Introduction

These comments address Nova Scotia Power's August 2023 updated Action Plan and Roadmap items from its 2023 Evergreen Integrated Resource Plan (IRP).

NSPI Input Assumptions for Wind and Solar ELCC

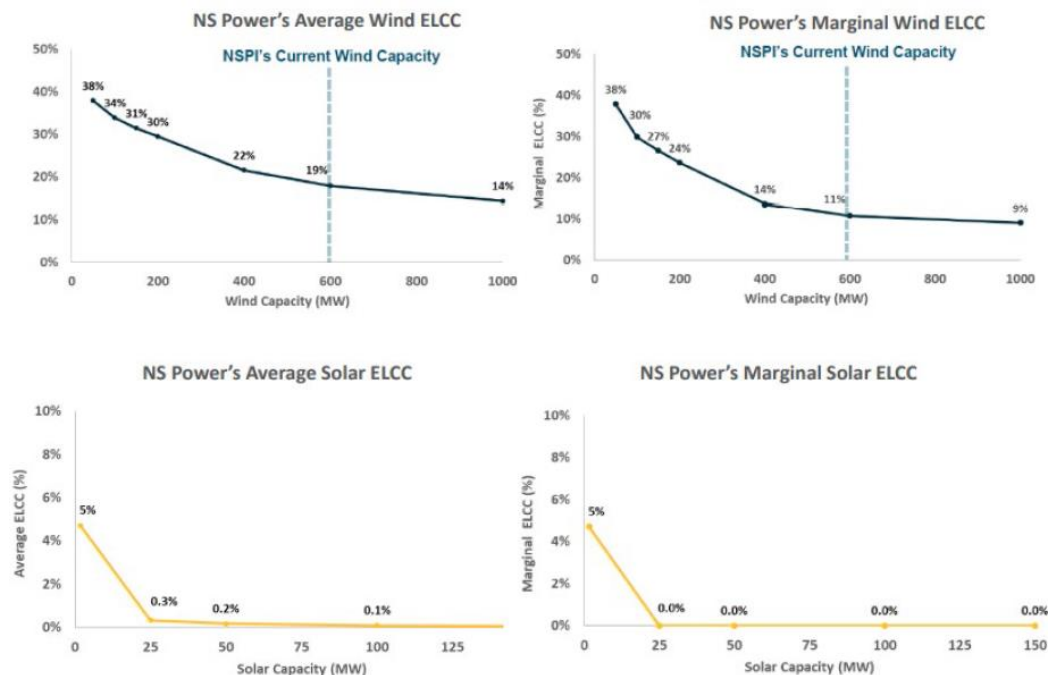
In our opinion, the pre-IRP capacity value study from 2019 (used in the 2020 IRP) does not fully capture the diversity effects that exist among battery energy storage, wind, solar, and demand response resources, and the capacity accreditation given to battery resources in this IRP update is too low. This affects the PLEXOS model optimization of capacity resources. Prior to the next IRP update, this study and the methods used to capture portfolio diversity should be updated. The new study should reflect the full measure of diversity effect considering all four of these resources, which are highly complementary in the provision of capacity. Demand response resources, or the equivalent capability of mitigating peak increases such as would be seen in the “hybrid peak mitigation” case, have a material influence on the peak load that might otherwise need a higher level of battery resources or other capacity resources to

As noted, the battery energy storage ELCC profile used in this IRP update is a critical input value to the modeling that needs to be carefully re-examined in the next IRP or IRP update. The re-examination needs to be conducted in conjunction with an updated “portfolio ELCC” analysis that better considers the interactive effect of all four clean resources (wind, solar PV, battery energy storage, and demand response or peak load mitigation during winter peak periods). The current input assumptions used for ELCC for the portfolio of resources, while reflecting some level of diversity benefit,⁴ do not fully capture this critically important dynamic. The effect of this shortcoming is a failure of the capacity expansion portion of the modeling exercise to fully capture the interactive effect and thus produce a potentially sub-optimal output in the selection of capacity resources.

Slide 27 from NSPI’s input assumptions slide deck contains the only fully descriptive information on the ELCC considerations, in addition to what is contained in the 2019 Pre-IRP Planning Reserve Margin and Capacity Value Study.

Below is a reproduction of the ELCC components for wind and solar; and while the Capacity Value Study includes more information on the portfolio effect for battery storage and wind, and for solar PV and wind, there is no information available about a combined wind/solar/battery/demand response portfolio combination, and what its impact would be on the modeling under different ELCC input assumptions.
